**NRC Audit at GE Office, San Jose, CA
June 5-8, 2006**

GE Status of Remaining Responses to RAI 3.7

Figure1.1 RB/FB model

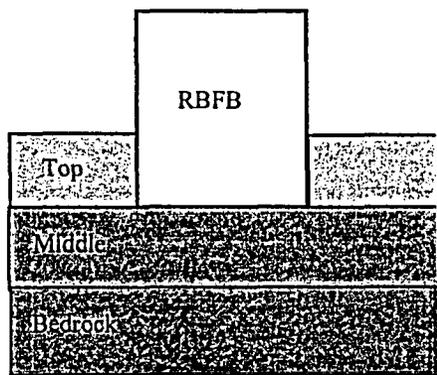
RAI Number	Question Summary	Full Text	Schedule	Status
3.7-57	<p>Demonstrate that the stick structural models developed based on the process described in the DCD can transmit frequencies up to 50 Hz and be able to capture the responses resulting from the high frequency components of North Anna input ground motions. (3.7.2)</p>	<p>DCD Tier 2, Section 3.7.2.3 indicates that the mathematical model of the structural system is constructed either as a stick model or a finite element model. These models are used in the soil-structure interaction (SSI) response analyses to determine seismic response of the soil structure system as indicated in DCD Section 3.7.2.4 and described in Appendix 3A to DCD Section 3.7. The free-field ground motions used as input to the plant analysis and design are described in DCD Section 3.7.1, and are ground motions that envelope either the RG 1.60 low frequency response spectrum or the high frequency ground motion developed for the North Anna early site permit site.</p> <p>DCD Figure 3.7-30 presents a plot of the North Anna design ground response spectrum and indicates a response spectrum that possesses its primary spectral accelerations in the frequency range from about 10 Hz to 50 Hz with a peak spectral acceleration at a frequency of about 20 Hz for the horizontal response spectrum and about 30 to 50 Hz for the vertical response spectrum. Appendix 3A to DCD Section 3.7 presents descriptions of the stick models developed for use in SSI analyses for the primary structures and internals of the plant. DCD Tables 3A.7-5 through 3A.7-14 present the results of eigenvalue analyses that are carried to frequencies as high as 27 Hz. These indicate participation factors of 0.28 at frequencies as high as about 25 Hz. The staff requests that the applicant demonstrate that the stick structural models developed based on the process described in the DCD can transmit frequencies up to 50 Hz and be able to capture the responses resulting from the high frequency components of North Anna input ground motions.</p>	8/18/06	<p>In progress. The CB stick model is being refined by adding additional mass points with the objective to show that the resulting responses are no more than 10% increase of the responses predicted from the original model.</p>
